Technical Bulletin

Bulletin No: TCH-003-042-A

Subject: BRAKE VALVE TREADLE REPLACEMENT – COACH APPLICATIONS

Figure 1 – Old Style Treadle

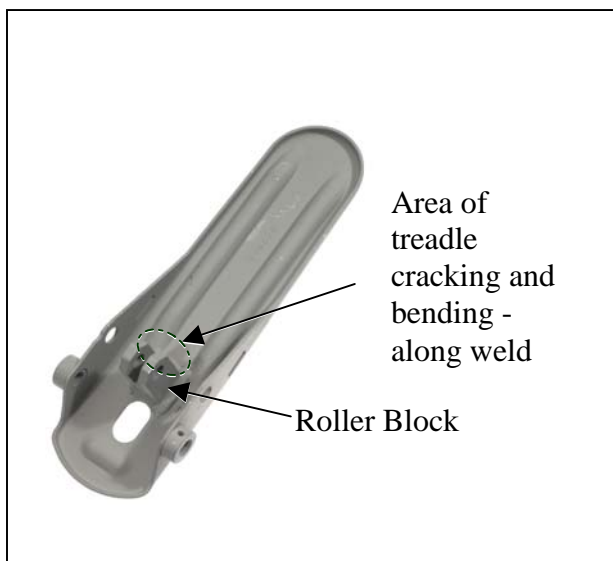
During normal use, some brake valve treadles may develop small cracks along the top surface, causing the brake valve treadle to bend. Over time this bend will result in a decreased treadle angle, which in turn will require an increase in braking effort by the vehicle operator. A quick visual inspection can identify if this condition is present.

A bump or worn spot present in the treadle cover, near the roller area, may indicate that the treadle is cracked and bent, pushing the cover up in the center. Removal of the treadle cover or inspection of the bottom side of the treadle will verify if this condition exists.

This condition is limited to coach applications with a treadle configuration as shown in Figure 1. This unique treadle has a roller block welded to the middle of its underside. The cracking occurs near this weld.

If this condition exists, the treadle assembly must be replaced with Bendix Treadle Assembly piece number **5000293**. As shown in figure 2, the new treadle does not contain a welded roller block in the center. Because of this design change, the roller and pin can not be interchanged from the old treadle assembly to the new. To facilitate installation, the treadle, treadle cover, pin, roller, cotter pin and fasteners are included with the new treadle assembly.
